- Development Plan Changes Rev. 6 (Feb. 2015)
- A. Section 1 has been absorbed into Sections L and M, therefore Section K no longer exists.
 - B. To avoid natural water buffers/features, the lots and road layouts in Sections L and M have been revised, and preliminary proposed grades provided. The lot size for Sections L and M have also been increased. Associated open spaces and lots in reserve have been adjusted accordingly.

The Highlands at Ladd Park
DEVELOPMENT PLAN - Revision 6

RESIDENTIAL SUBDIVISION
WILLIAMSON COUNTY, TENNESSEE

C.O.F. PROJ. # 5800

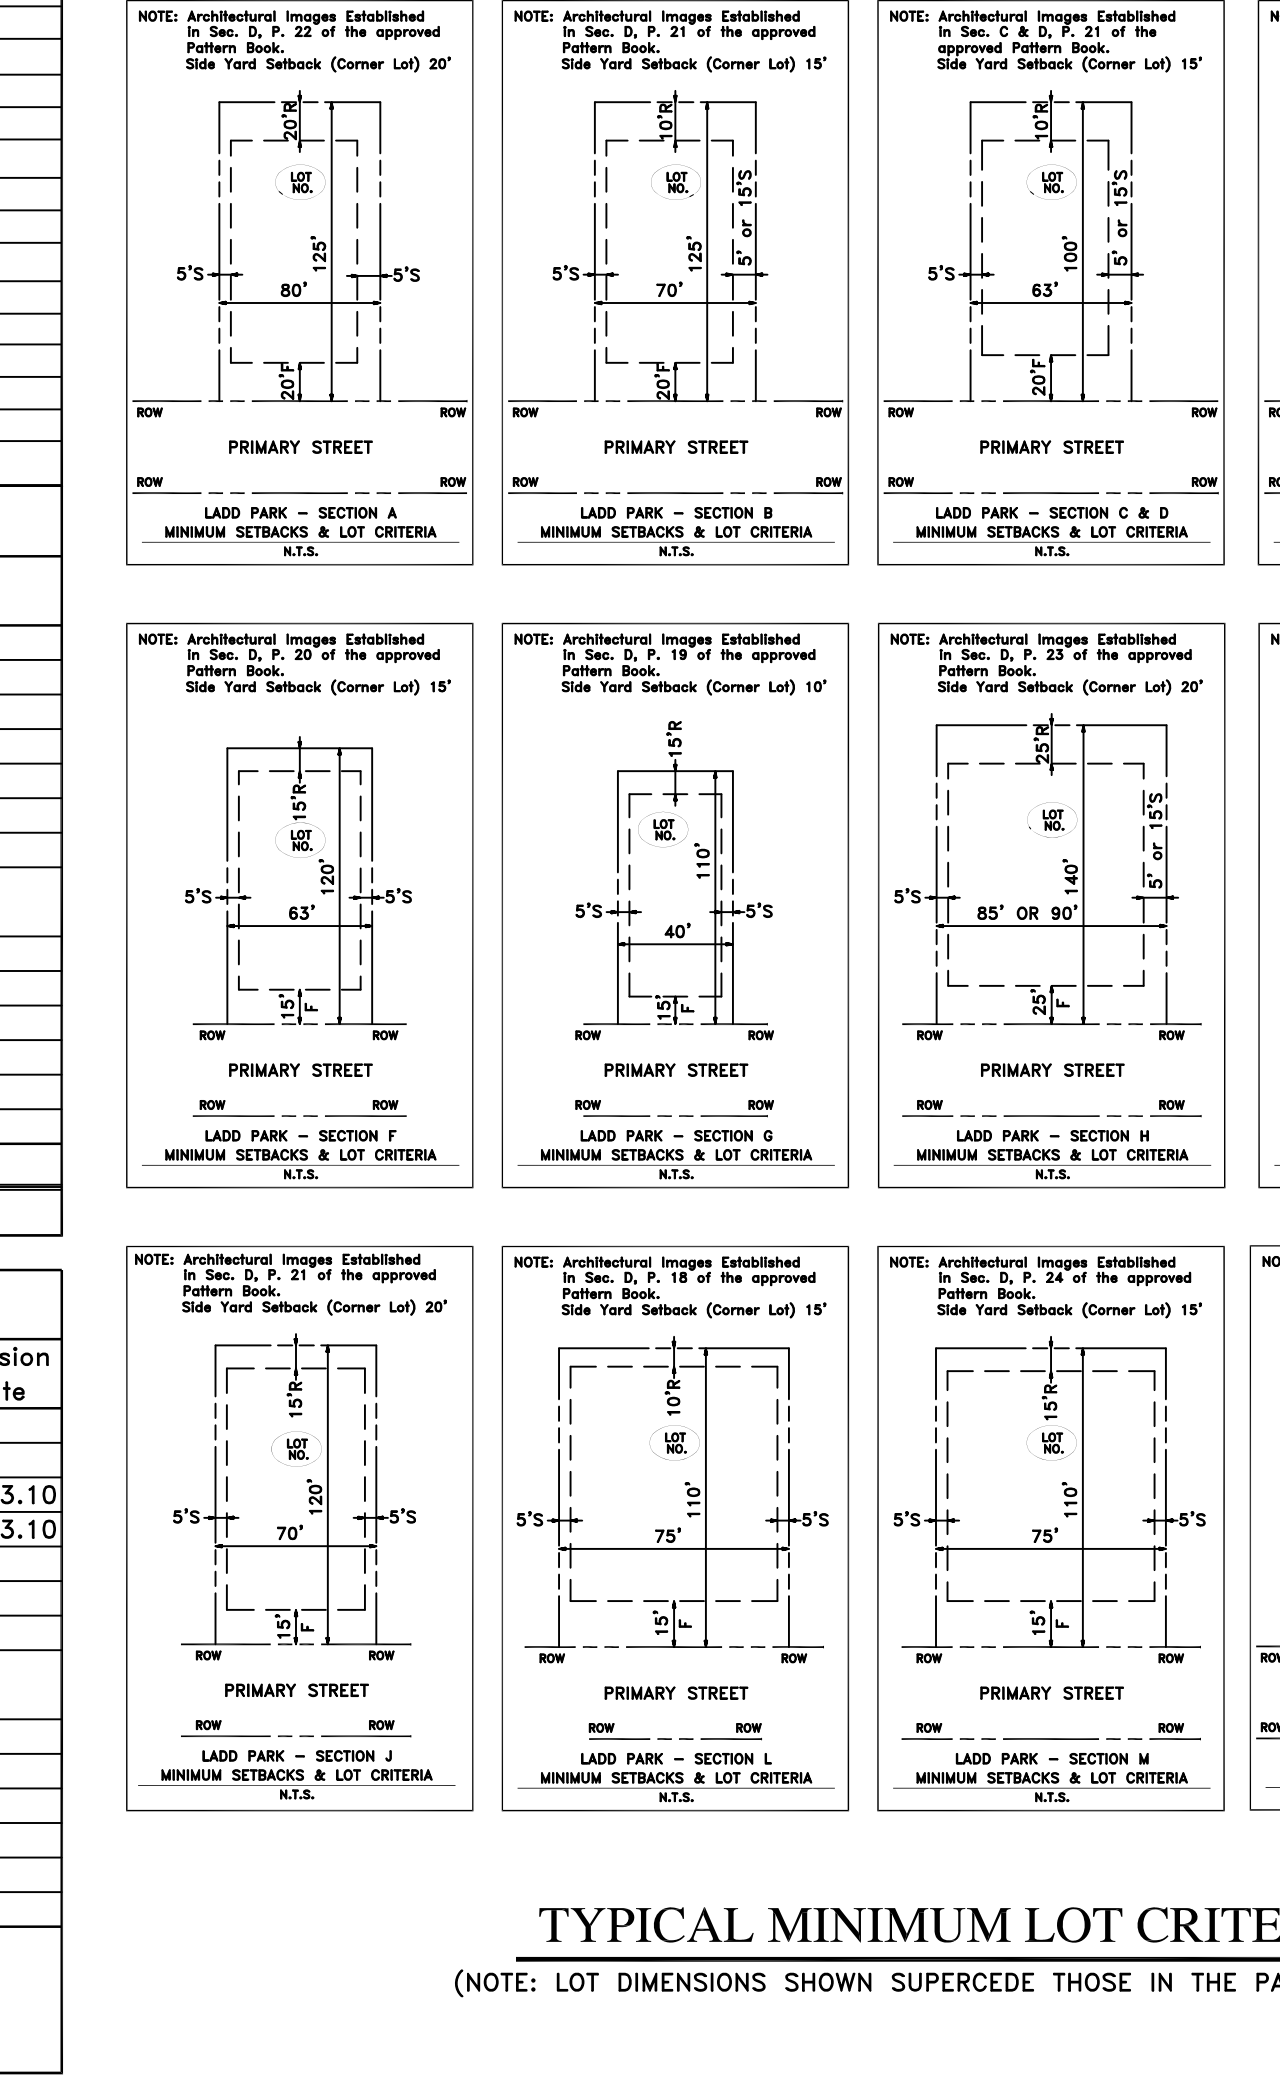
- C. Sections 11, 13, 15, 21 - 25 and 27 are now shown as approved, and associated open spaces given recorded lot number and acreage.
 - D. Section N has been completely revised, according to comments received from the City of Franklin staff.

- E. Open Space 14 has been converted to a Lot in Reserve.
 - F. Eight lots have been added in a previous Lot in Reserve along Alfred Ladd Road West at the main entrance to the subdivision at Long Lane.

- G. Because of the above revisions, all Open Space and Lot charts have been revised accordingly.
 - H. Lot count has been increased from 1150 to 1203, resulting in an increase of 53 lots. The revised density is 1.94 units/AC.

- I. Carothers Pkwy. has been constructed, therefore the typical section has been removed to provide additional space on this sheet.
